### **DIRECT PUSH GROUNDWATER CONTINUATION SAMPLING AND ANALYSIS PLAN**

**FINAL  
Revision 2**

**RE: Revision 2 – Draft 2009 Direct Push Groundwater Continuation Sampling and Analysis Plan** *BSK*

Re: *Direct Push Groundwater Continuation Sampling and Analysis Plan, Revision 0*,  
April 2009

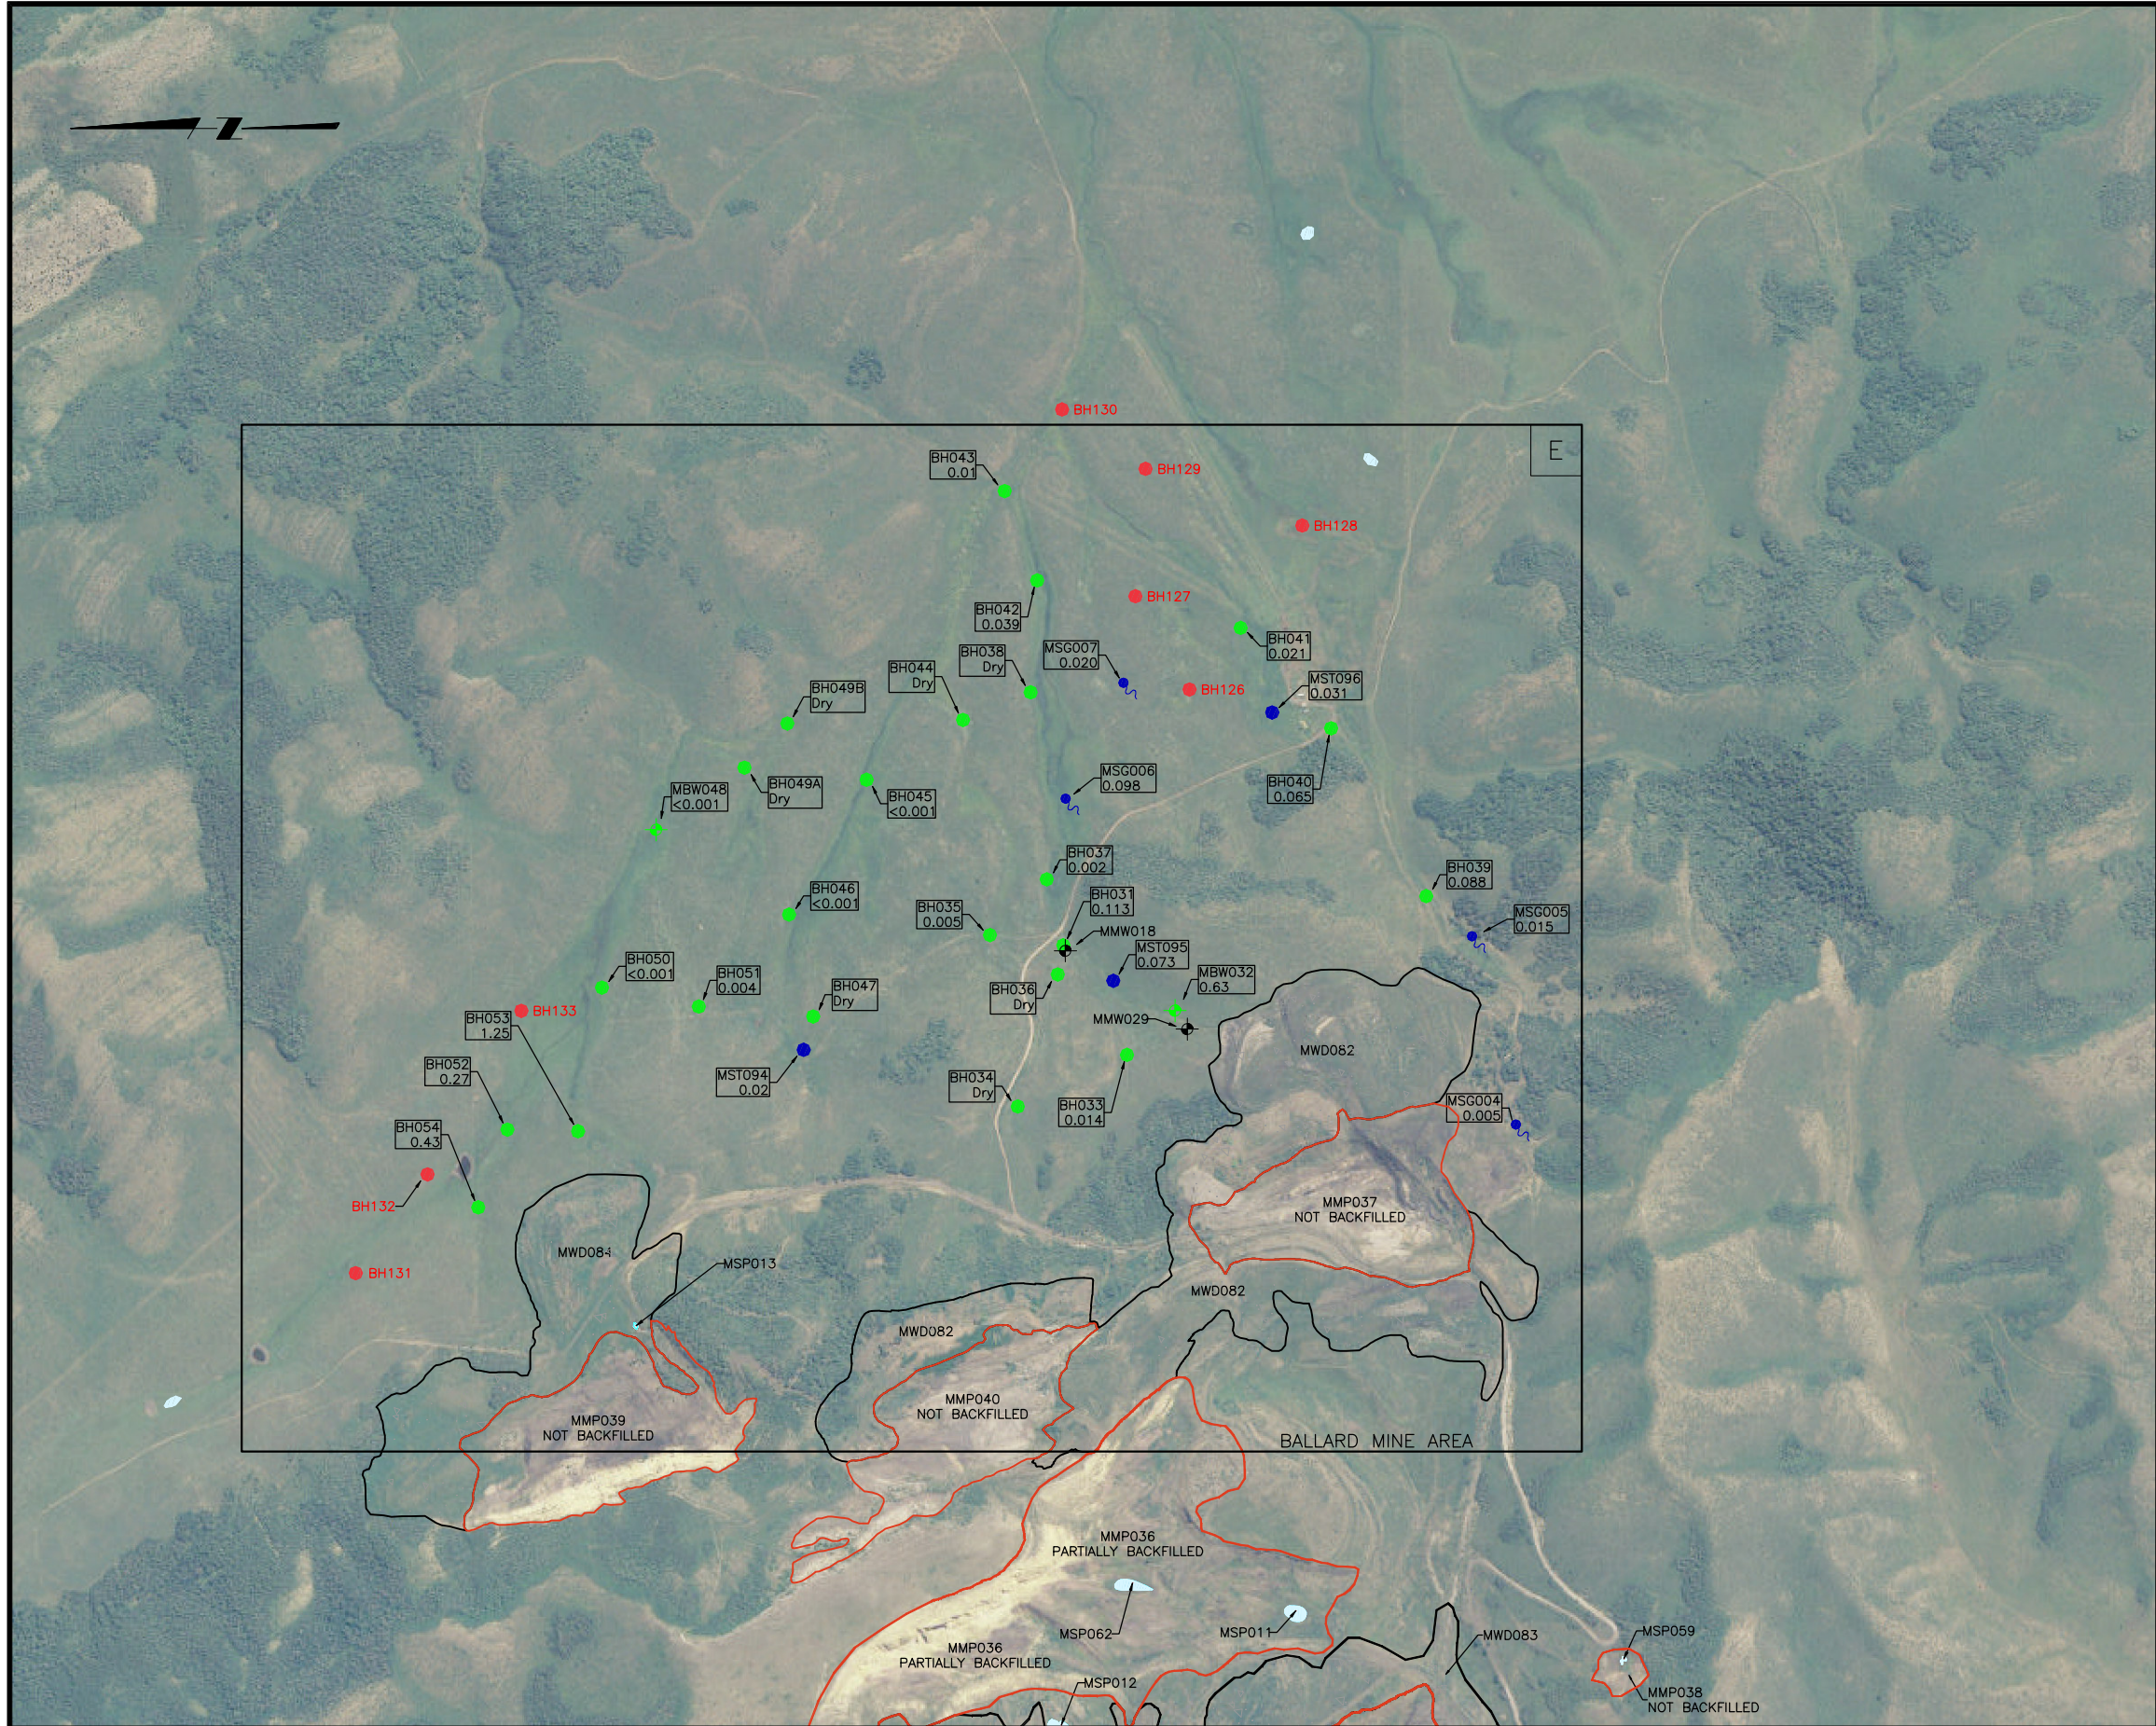
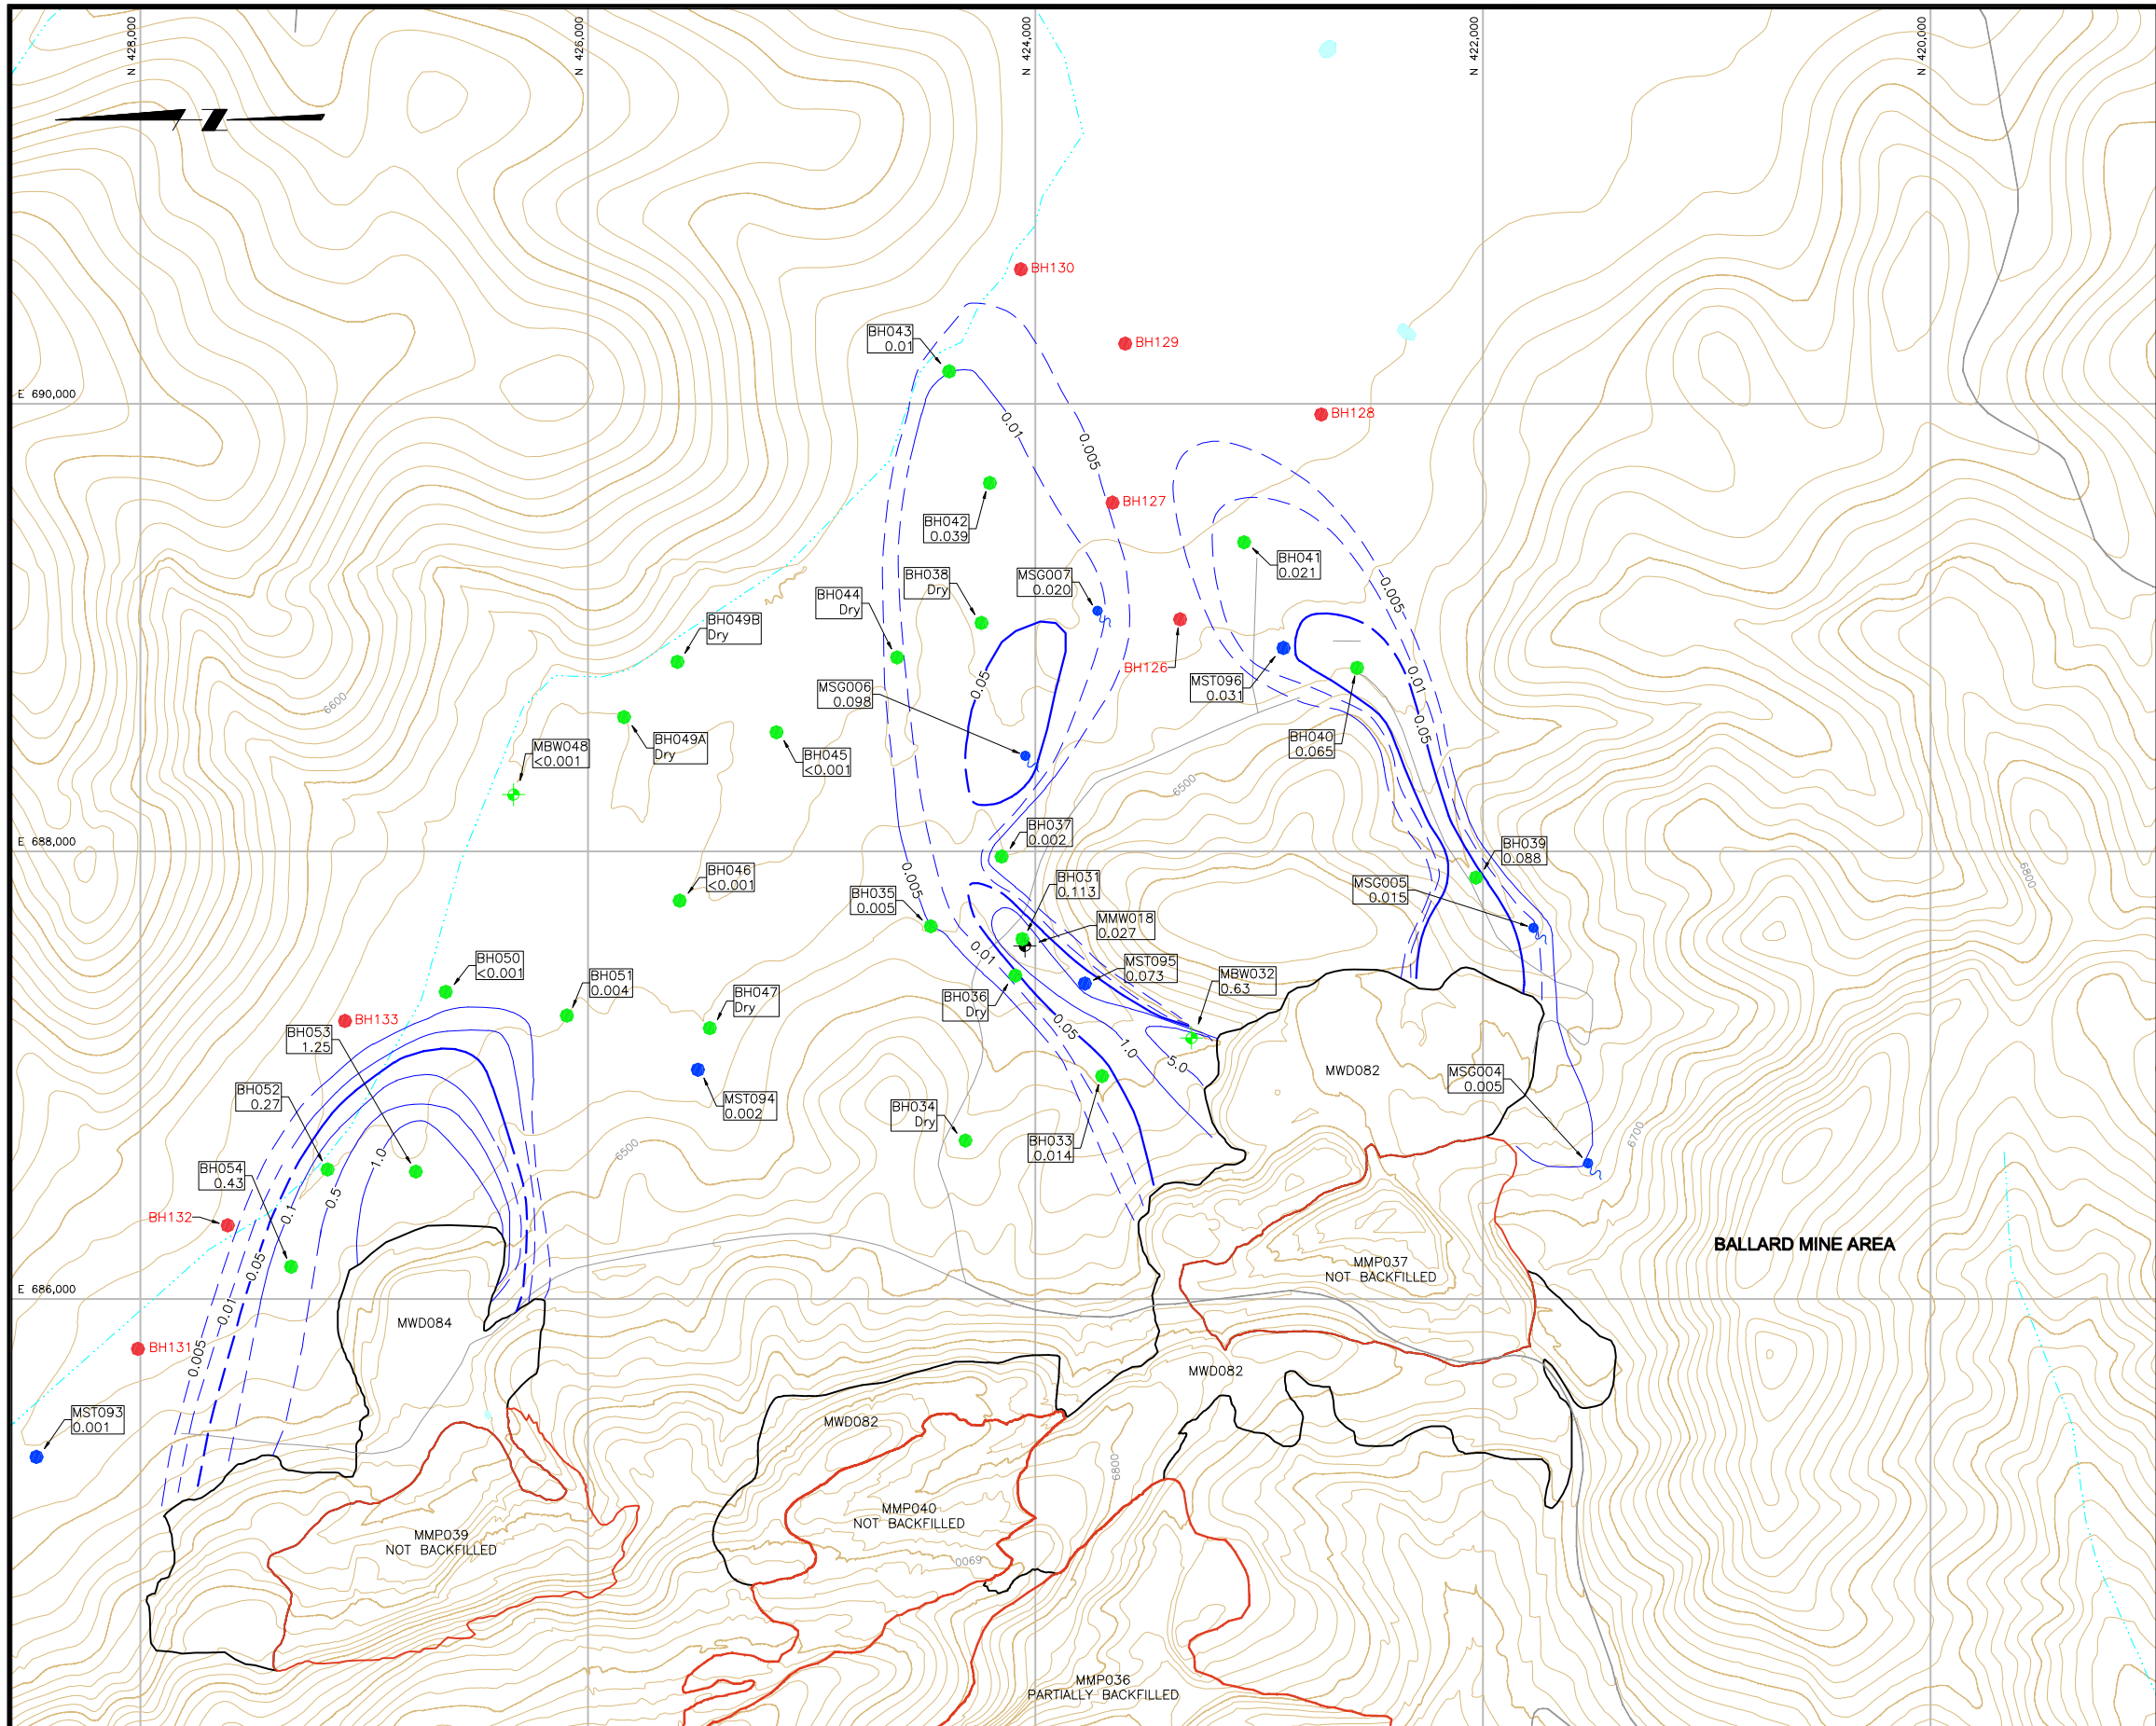
- As discussed during the 14 April 2009 meeting between P4/Monsanto, MWH, Agencies, and Tribes in Pocatello, DP borehole locations should be added to better define the extent of the selenium plume east of Ballard Mine MWD084.
  - Additional investigation is needed between MST093 and BH054 to better define the northern edge of the selenium plume.
  - Additional investigation is needed northeast of BH052, BH053, and BH054 to determine if the plume actually crosses the adjoining local drainage channel, as depicted in Drawing 3.

- As discussed during the 14 April 2009 meeting between P4/Monsanto, MWH, Agencies, and Tribes in Pocatello, DP borehole locations should be added to better define the extent of the selenium plume east of Ballard Mine MWD084.
  - Additional investigation is needed between MST093 and BH054 to better define the northern edge of the selenium plume.
  - Additional investigation is needed northeast of BH052, BH053, and BH054 to determine if the plume actually crosses the adjoining local drainage channel, as depicted in Drawing 3.

Response: *Three addition boreholes have been added on the northern and eastern sides of the plume originating from MWD084 as shown on the revised Drawings 2 and 3.*

Response: *Drawings 2 and 3 have been revised to show three additional boreholes to address that areas indicated in the comment.*
